BHARAT HEAVY ELECTRICALS LIMITED
TRANSMISSION BUSINESS ENGINEERING MANAGEMENT
NOIDA

COPYRIGHT & CONFIDENTIAL The information in this document is the property of BHARAT HEAVY ELECTRICALS LIMITED This must not be used directly or indirectly in anyway detrimental to the interest of the company.	DOCUMENT NO.	TB-402-316-001	Rev 01	Prepared	Checked	Approved
	TYPE OF DOC.	TECHNICAL SPECIFICATION	NAME	DKS/AA	SKS/VK	RS
	TITLE 66kV Gas Insulated Switchgear (GIS) with Local Control Cabinet (LCC) & Control Relay Panel (CRP) (Suitable for coastal & highly corrosive environment)		SIGN	-sd-	-sd-	-sd-
			DATE	28.05.2018	28.05.2018	28.05.2018
			GROUP	TBEM		
			WO No.	87010		
	CUSTOMER	Hindustan Petroleum Corporation Limited (HPCL)				
	PROJECT MANAGEMENT CONSULTANT (PMC)	Engineers India Limited (EIL)				
	PROJECT	66 KV GIS system for CPP package for Visakh Refinery Modernization Project (VRMP), Vishakhapatnam.				
	TENDER NO./ NOA NO.	17000406-HP-46004/AK dtd. 15.02.2018				
Contents						
Section No.		Description			No of Pages

BHEL's reply to EIL/HPCL comments

PROJECT: VRMP PROJECT, VIZAG
NAME OF PACKAGE: CPP package

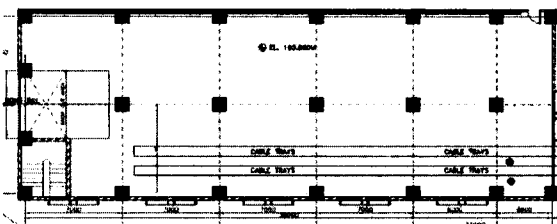
1.1	Document title in VPortal is indicated as "33 kV GIS Layout" which is misleading. Correct the document title as "Switchgear room equipment layout for SS-93".	Noted.

1.2	The resolution sheet mentions that the comments have been incorporated; however it is observed that the comments were not incorporated in the drawing. The pending points are highlighted against resolution. Contractor shall incorporate the same.	Points are once again mentioned along with resolutions for review.

1.3	Comments during discussions of MOM 3rd, 4 th April 2018 have not been incorporated. Contractor shall provide the resolutions and incorporate in the revised drawings.	Noted and incorporated in the revised layout drawing

1.4	The locations of various electrical equipments shall be as per MOM dtd 3rd, 4th April 2018. Accordingly, ECS workstations, Data concentrator HMI, ECS video wall shall only be placed in Electrical control room. Panels such as RTCC panels, Generator relay panels, DAVR panels, Data concentrator panels, ECS RTUs, ECS interface panels, PA system exchange shall be placed in Electrical room. DGFAP panels shall be located in instrumentation rack room.	Noted and incorporated in the revised layout drawing

1.5	Indicate cable trays under CRP of 66kV GIS.	This was only indicative. However, actual arrangement of trays in cellar will be indicated separate drawing. Please refer the 66kV cable cellar cable tray layout drawing for details of cable trays

1.6	Indicate the escape routes in the cable cellar under 66kV GIS. Also specifically address the escape route for person standing at the RED dot as below: 	This was only indicative. However, actual arrangement of trays in cellar will be indicated separate drawing. Please refer the 66kV cable cellar cable tray layout drawing for details of cable trays

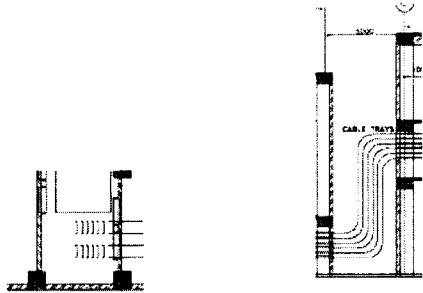
SL. NO.	COMMENT/ OBSERVATION	BHE's reply to EIL/HPCL comments
1.7	5 Meter clearance between 66kV GIS building and the process control room shall be checked with respect to the bending radius of the 66kV cables, tray to tray clearance. Contractor shall provide number of detailed arrangement of cables along with the tray sizing calculations. 	This was only indicative. However, actual arrangement of trays of cable trays will be indicated in separate drawing. Please refer outdoor area cable tray/trench layout for details (Dwg.No: PY-LC-0-M104-2001-01-S01-R00)

1.8	It is observed that there is no adequate clearance for escape route especially near 66kV cable trays passing under 33kV GIS cellar. Indicate the escape routes in the cable cellar under 33kV GIS. Also specifically address the escape route for person standing at the RED dot as below: 	This was only indicative. However, actual arrangement of trays in cellar will be indicated separate drawing. Please refer the 66kV cable cellar cable tray layout drawing for details of cable trays

1.9	Indicate the entrance for VAM room 	Noted and incorporated revised layout.
1.10	Include section details of the battery room. 	Battery room sections will be indicated after finalization of UPS system

1.11	Please check and correct the Grid numbers „E, F, G” at EL 115.100M.	Noted and incorporated in the revised layout drawing
